**STATE OF DELAWARE
EXECUTIVE DEPARTMENT
OFFICE OF STATE PLANNING COORDINATION**

RE: PLUS review – 2012-11-01; Overbrook Town Center

According to the information received, you are seeking a rezoning from AR to CR-1 for an 895,000 sq. ft. shopping center.

Figure 1: Map showing proximity of project to the Great Marsh

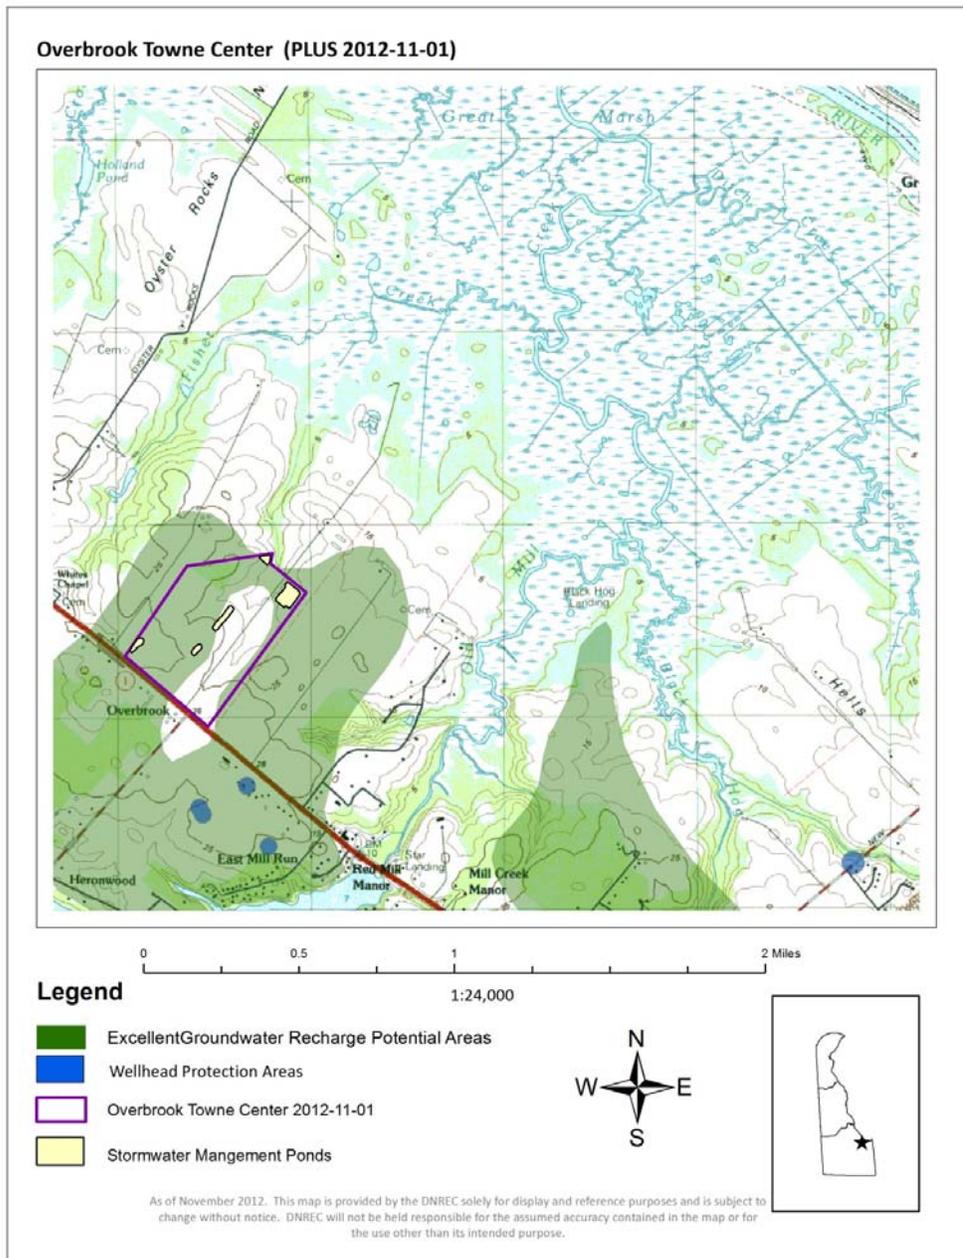
- The DNREC Water Supply Section, Ground-Water Protection Branch (GPB) has determined that a significant portion falls within an excellent ground-water recharge potential area for the Sussex County. The site plan indicates that stormwater management ponds and a significant amount of impervious cover fall within the area of excellent groundwater recharge. This project falls within Strategies for State Policies and Spending (SSPS) Investment Level 3 area (Figure 1).

- The site plan shows stormwater management ponds in the area of excellent groundwater recharge potential (Figure 1). The construction phase of storm water management ponds requires excavation, hauling, and grading. The heavy equipment used in this phase has the capacity to compact and degrade the structure of the strata that defines the area as an excellent ground-water recharge area (Schueler, 2000). Changes to the structural soil properties may cause significant reduction in recharge capacity. Installing storm-water management ponds in excellent ground-water recharge areas has the potential to contaminate the ground water beneath it and infiltrate into the aquifer.

From a hydrogeologic perspective, this excellent ground-water recharge potential area is located in a SSPS Level 3 area where environmental constraints should be considered. This recharge area is located between Fisher Creek and Old Mill Creek. These Creeks flow into the Great Marsh. Disrupting the infiltration process of this recharge area has the potential to introduce greater volumes of runoff to the Great Marsh and reduce the volume of water recharged to the unconfined aquifer (Figure 2).

- Ground Water Protection Branch recommends:
 - Keep impervious cover to less than 50%
 - Perform an environmental assessment report showing that water quality as well as water quantity of post development recharge is equal to or greater than pre-development recharge (Kaufmann, 2005).

- Quantify amount of recharge lost due to impervious cover and provide for onsite infiltration of water at least equal to or greater than pre-development recharge (Kaufmann, 2005). Also outlined in Sussex County Source Water Protection Ordinance No. 1979 §89-7, A. (2).

- Pretreatment of parking area runoff to remove dissolved chemical and nutrient loads prior to infiltration
 - Use Better Management Practices in the design, construction, and maintenance of a stormwater management system designed to address water quality with respect to nutrient and other pollutant loads.
